Wisconsin Department of Transportation

Proposal #18: 2430-06-70, WISC 2017 164
Colony Avenue
7th Avenue to STH 20
USH 45
Racine County

This is Addendum No. 01, which provides for the following:

ADDENDUM NO. 01

Addendum No. 01
 ID 2430-06-70
 Revised Sheet 301
 March 31, 2017

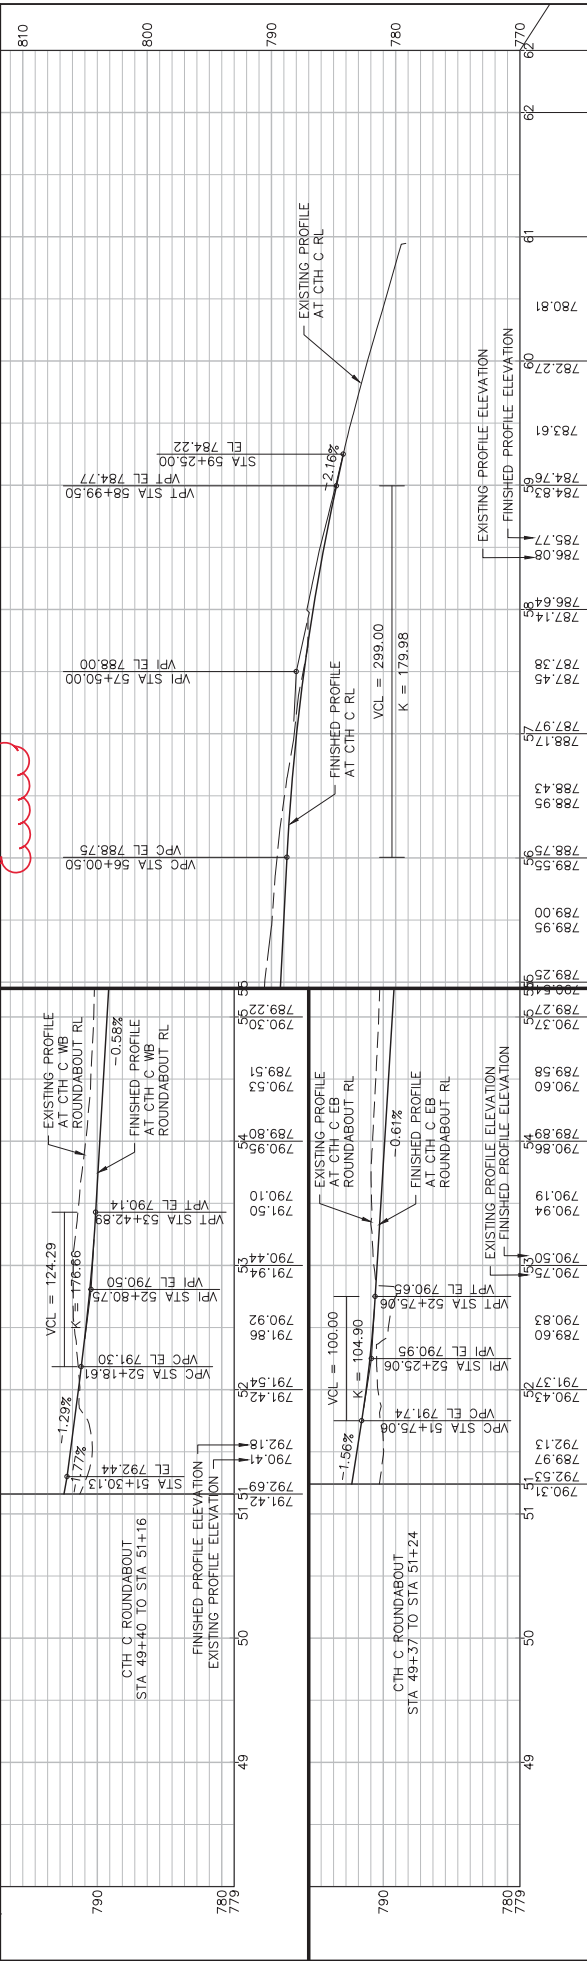
| Revised Plan Sheets | |
|---------------------|--|
| 301 | Plan and Profile: CTH C (revised proposed driveway) |

Addendum No. 01
 ID 2430-06-70
 Revised Sheet 497
 March 31, 2017

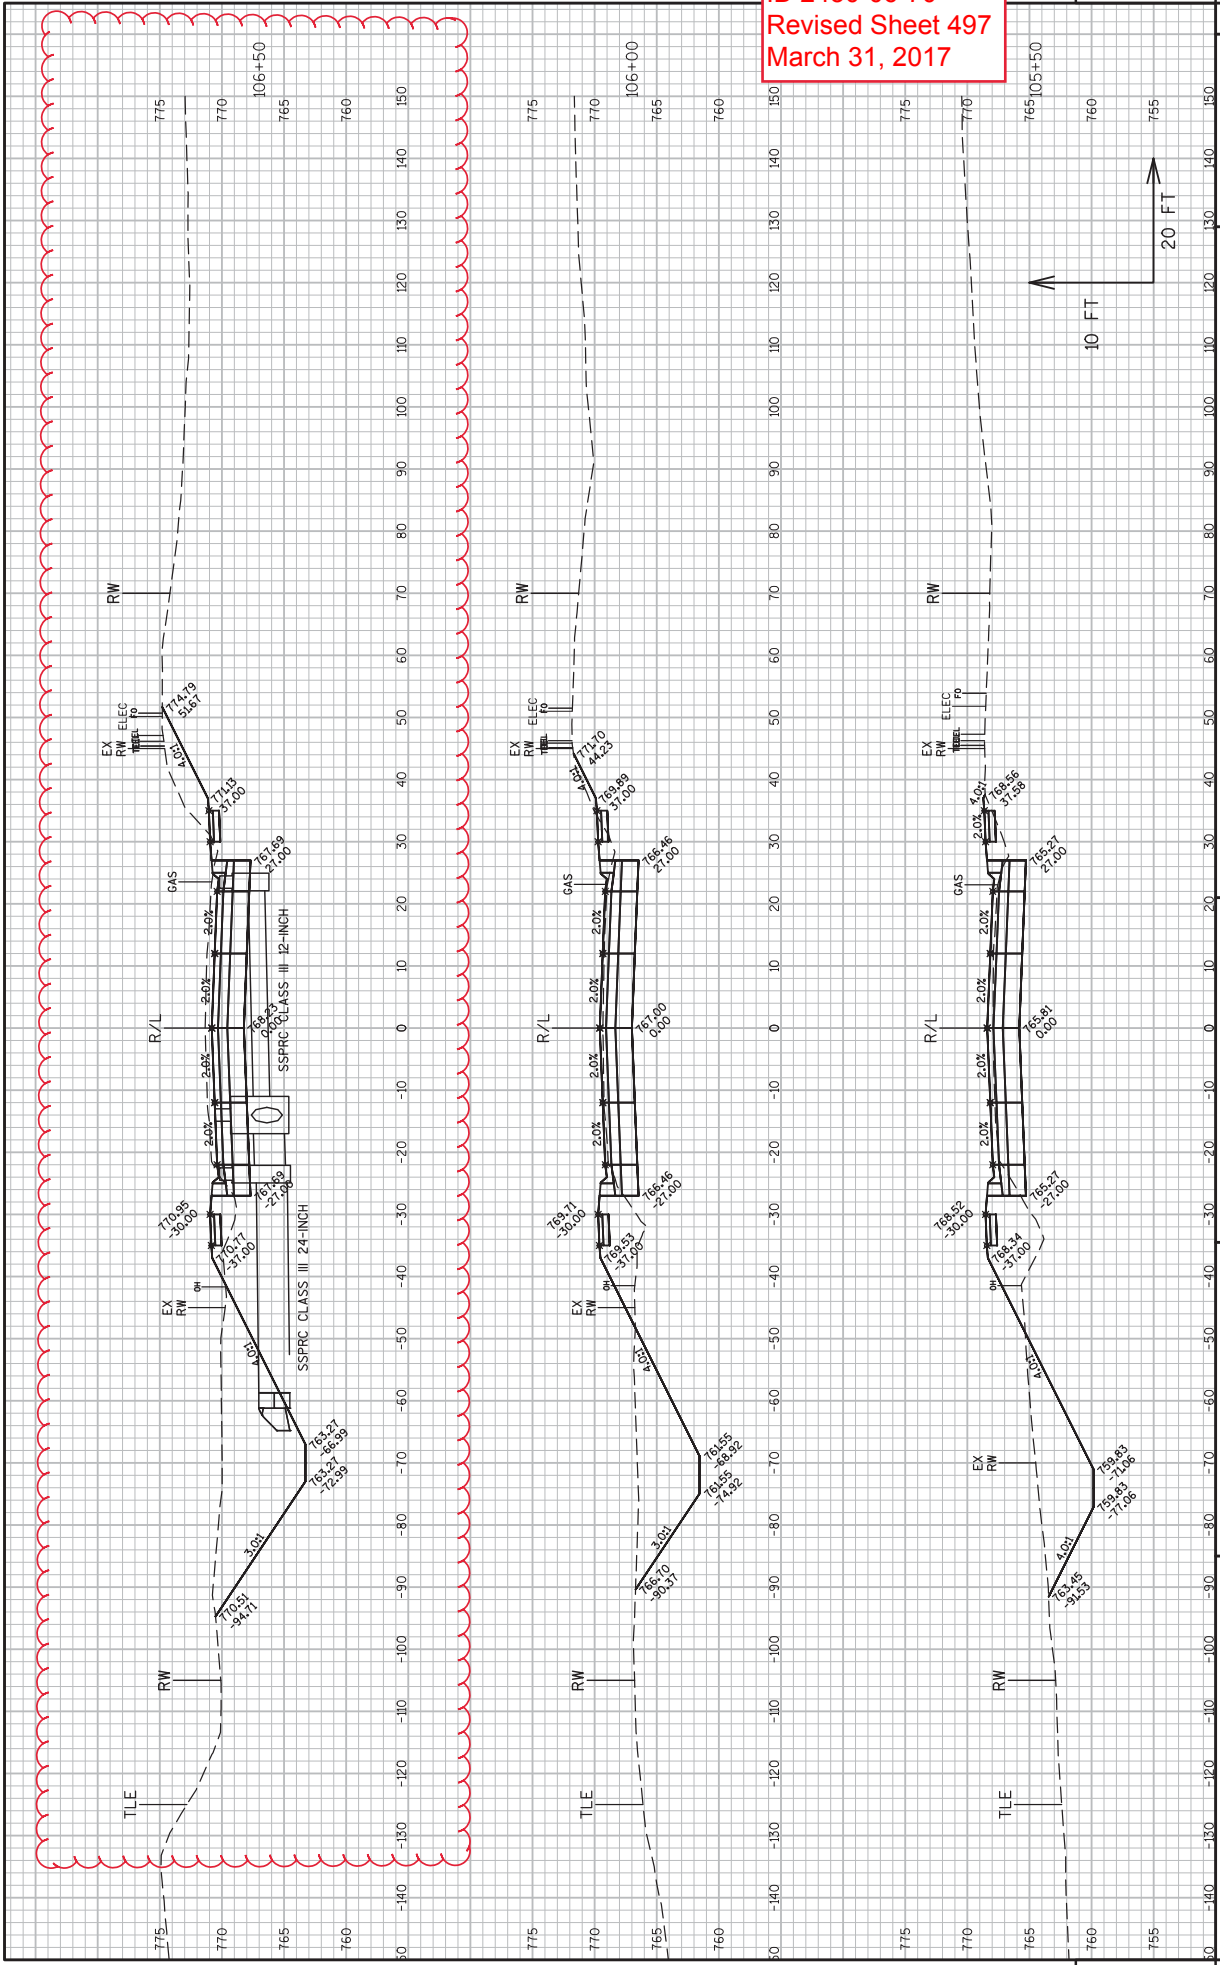
| Revised Plan Sheets | |
|---------------------|--|
| 497 | Cross Sections: USH 45 (revised storm sewer STA 106+50) |

Addendum No. 01
 ID 2430-06-70
 Revised Sheet 498
 March 31, 2017

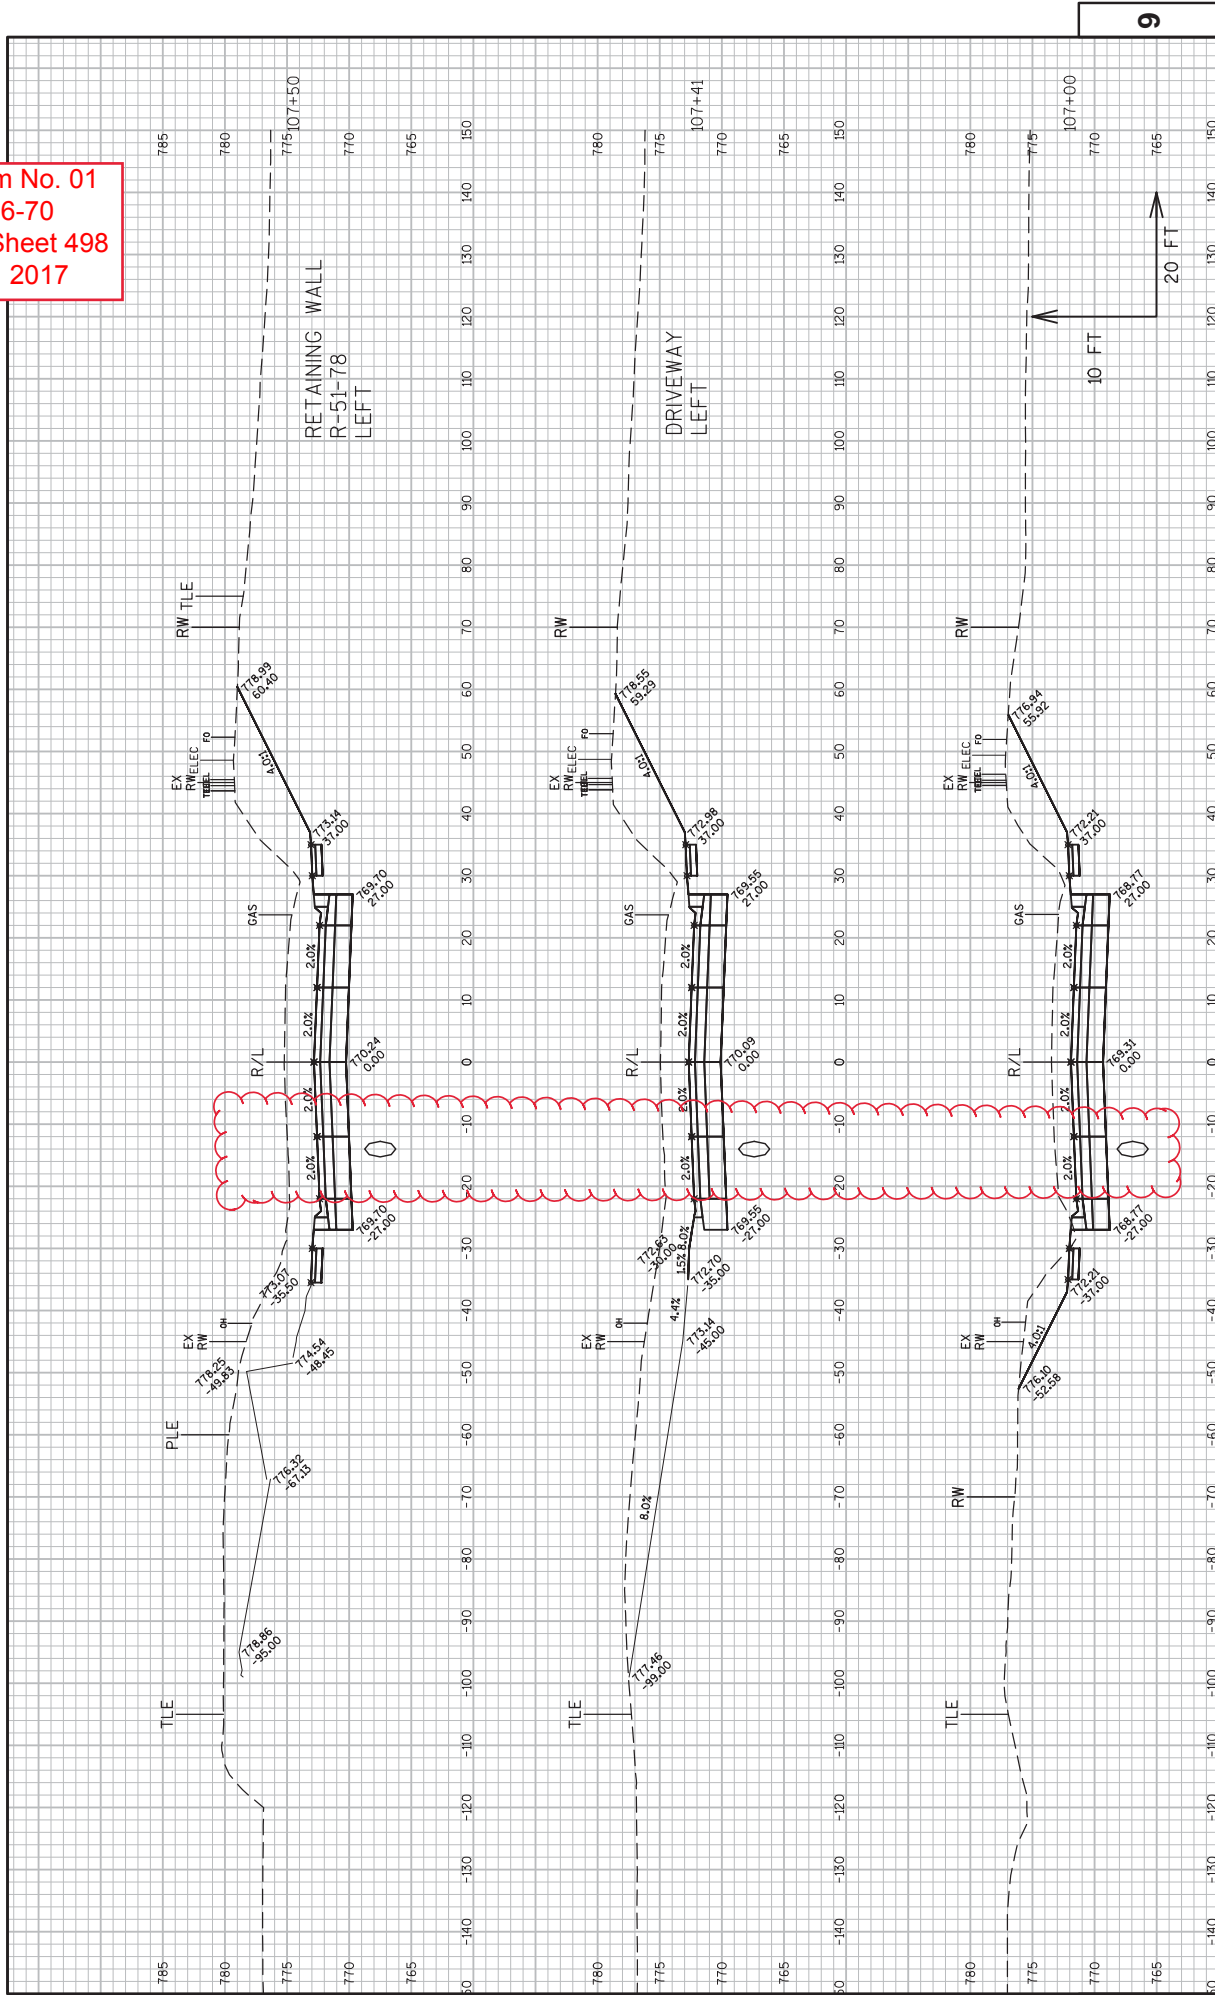
| Revised Plan Sheets | |
|---------------------|--|
| 498 | Cross Sections: USH 45 (revised storm sewer) |

Addendum No. 01
 ID 2430-06-70
 Revised Sheet 499
 March 31, 2017

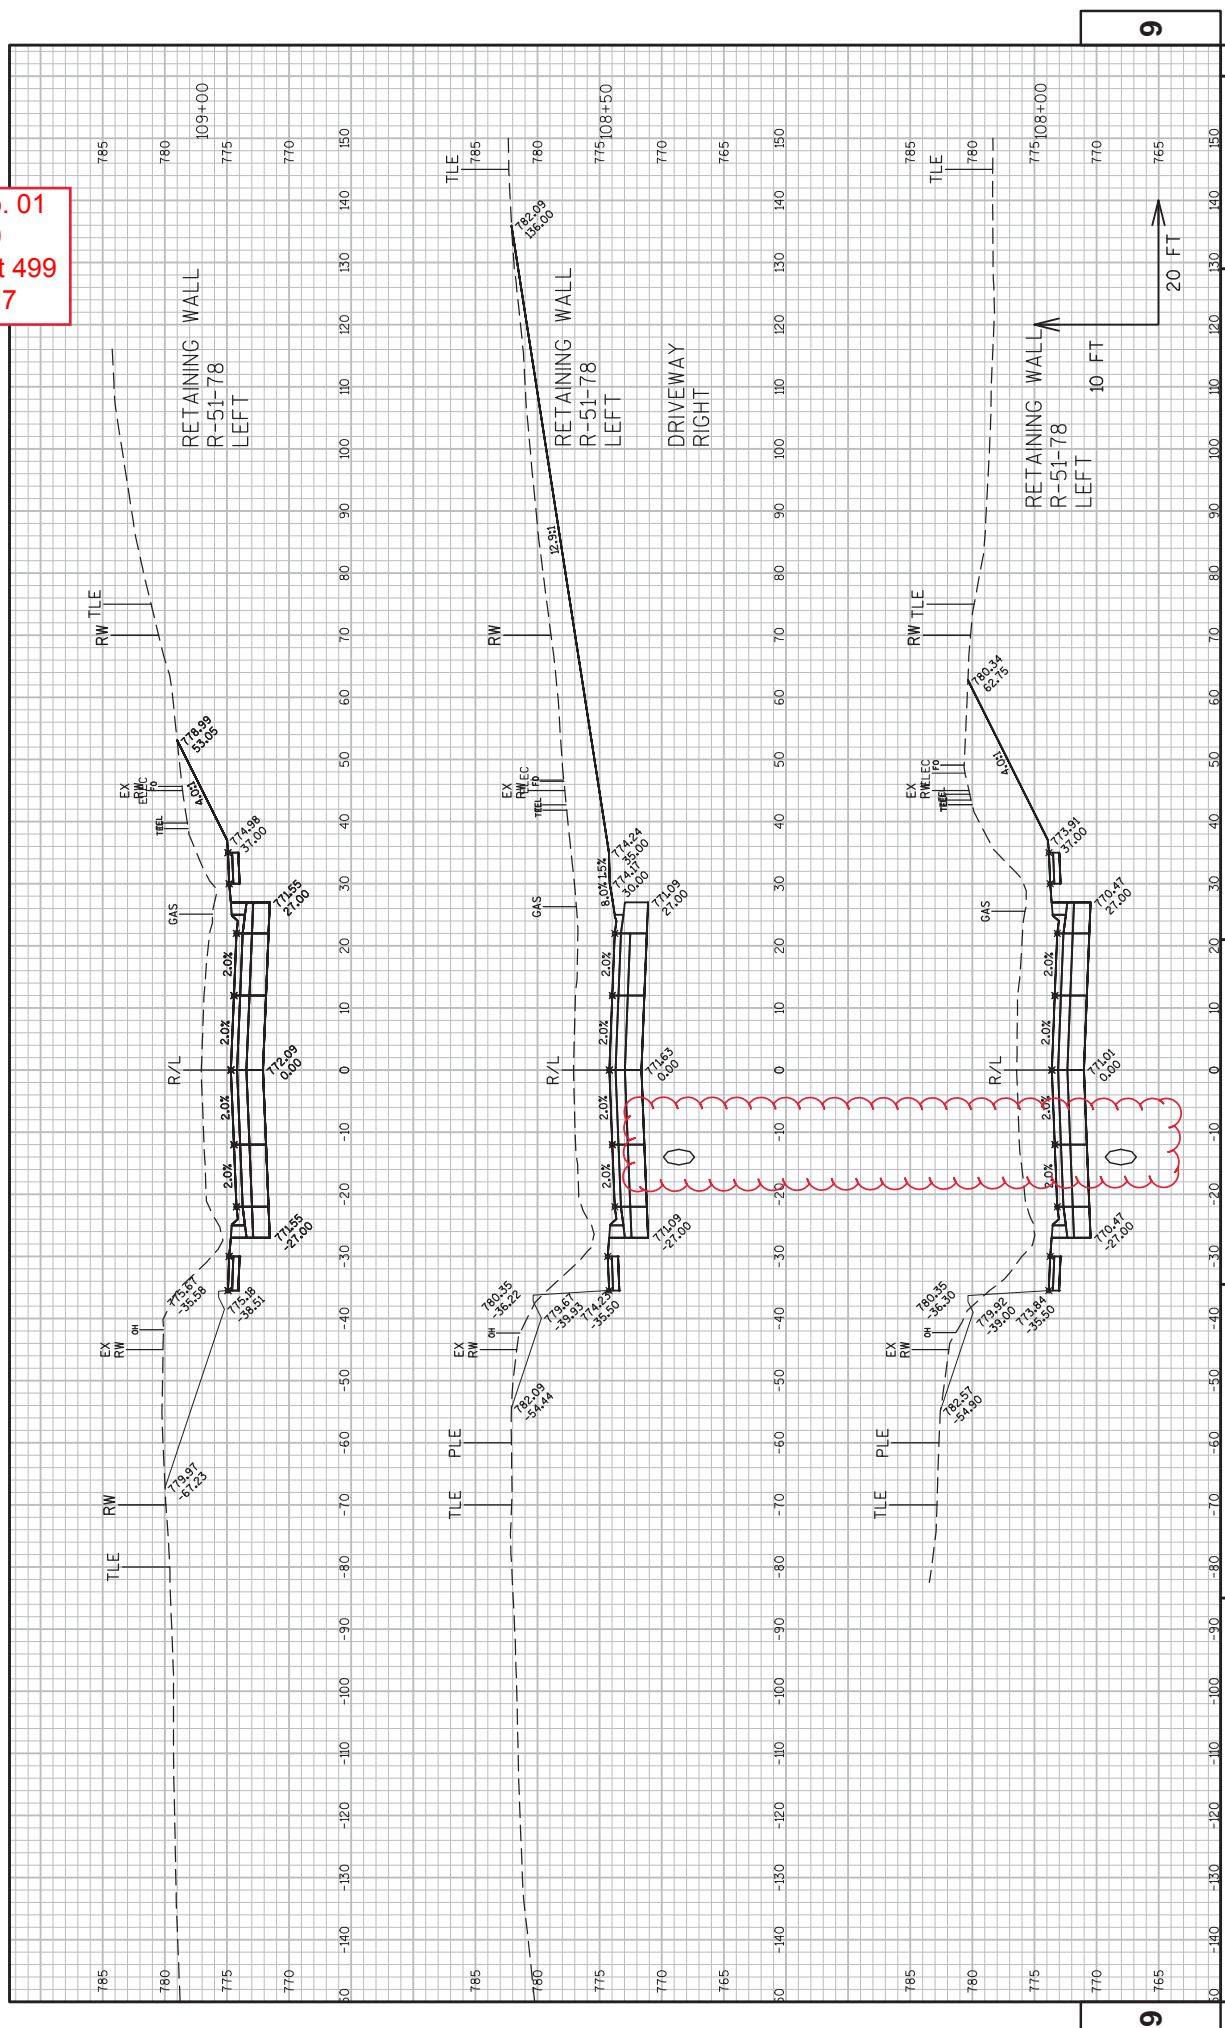
| Revised Plan Sheets | |
|---------------------|--|
| 499 | Cross Sections: USH 45 (revised storm sewer) |

Addendum No. 01
ID 2430-06-70
Revised Sheet 505
March 31, 2017

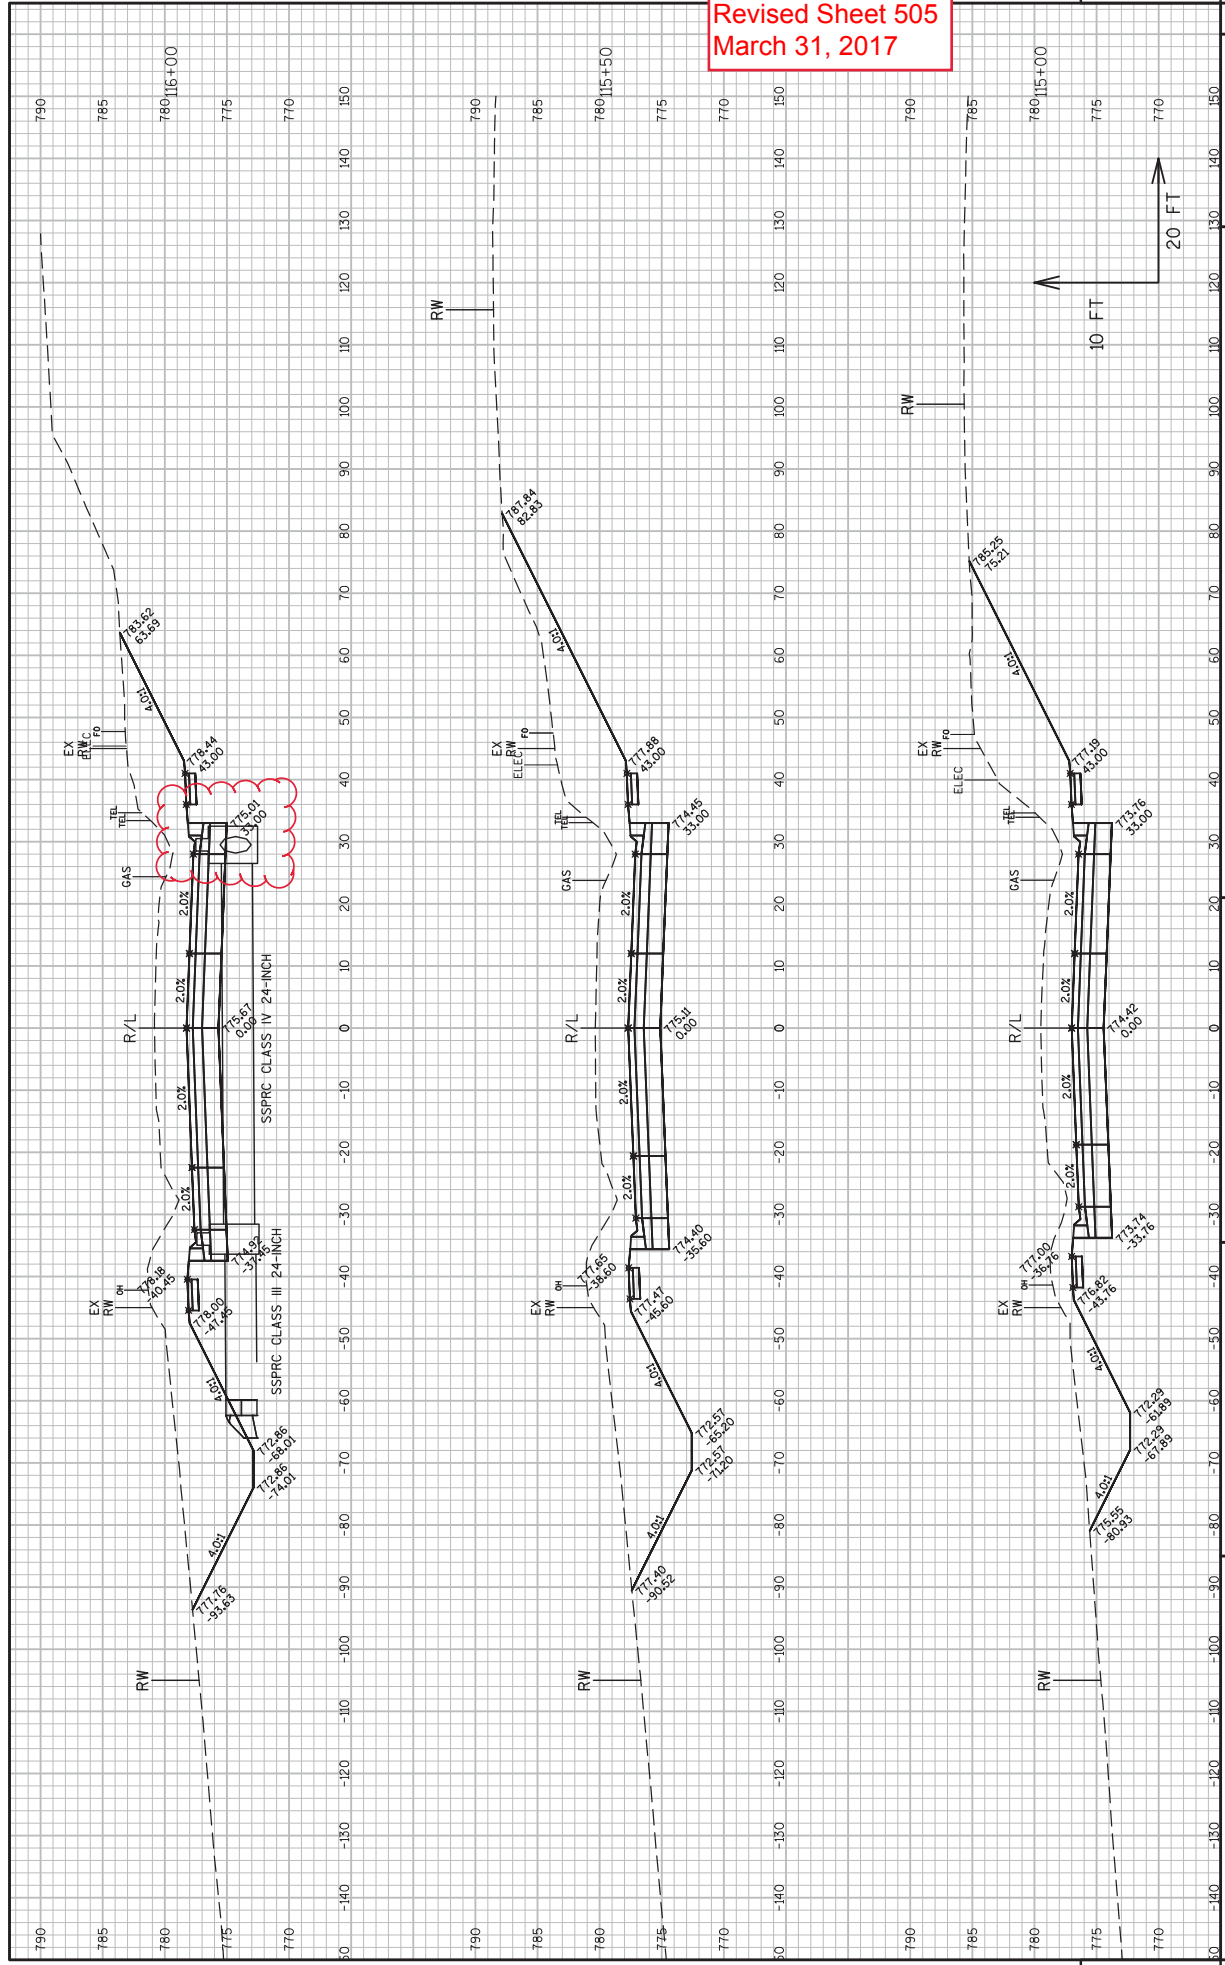
| 505 | Cross Sections: USH 45 (revised storm sewer STA 116+00) |
